# 1978 Corvette: Service Bulletin: Removable Roof Panel Fit

**Subject:** Removable Roof Panel Fit  
**Model and Year:** 1978 Corvette  
**Source:** Chevrolet Dealer Service Technical Bulletin  
**Bulletin No:** 78-T-23  
**Section:** I  
**Date:** April, 1978

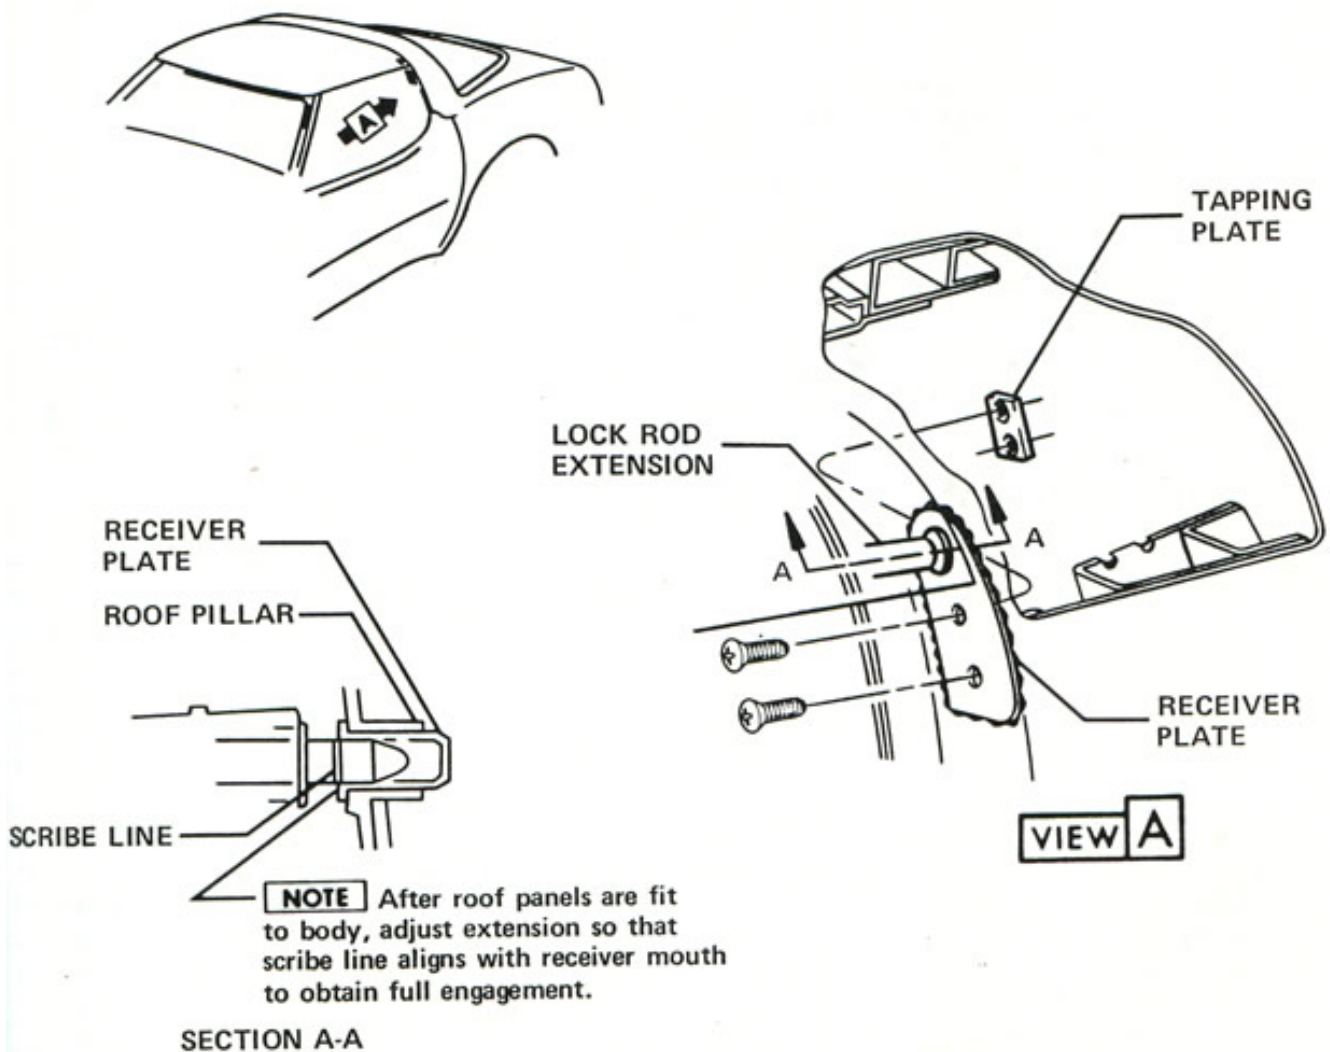
Some early 1978 Corvette removable roof panels may be bowed in relation to the windshield header and/or rear roof. This condition can be caused by an improperly positioned roof lock receiver plate.

1. Remove the rear roof corner garnish and lower roof trim panel.  
NOTE: It is not necessary to remove the shoulder belt or retractor.
2. Remove the roof lock receiver plate screws. Hold the tapping plate, located behind the roof pillar, to prevent it from falling (see illustration on page 2). Remove any excess sealer from pillar and receiver plate.
3. Using a small round file, elongate (lower) the three holes in the roof pillar as required to obtain a relaxed roof panel with a flush fit. This will be a trial and error process of installing the receiver plate and checking that the roof panel lock rod extension engages easily.

The bow in a roof panel can be eliminated by lowering the roof lock receiver plate as outlined below:

4. When an acceptable roof panel fit is achieved, thoroughly pack the area behind the receiver plate with 3M Strip-calk or equivalent.
5. Reinstall interior trim panels.
6. Adjust the door glass to the roof weatherstrip as described in Section 2D, 1978 Service Manual.
